ADA Curb Ramp New Construction Inspection Form (Parallel)

Nw 314th ave.

24952.54

Nw. Cottage st

PARALLEL RAMP (PL)

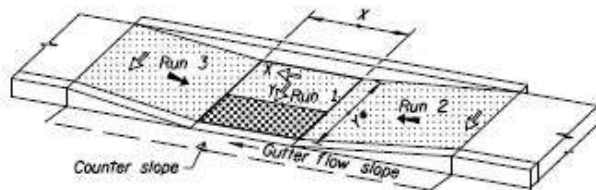
9.4 $\leq 2.0\%$ ☐ $> 2.0\%$ ☒

0.5 $\leq 1/4"$ ☐ $> 1/4"$ ☒

N Y ☐ N ☒

12.6 $\leq 8.3\%$ ☐ $> 8.3\%$ ☒

13.4 $\leq 8.3\%$ ☐ $> 8.3\%$ ☒

No dome, no RR2, no RR3
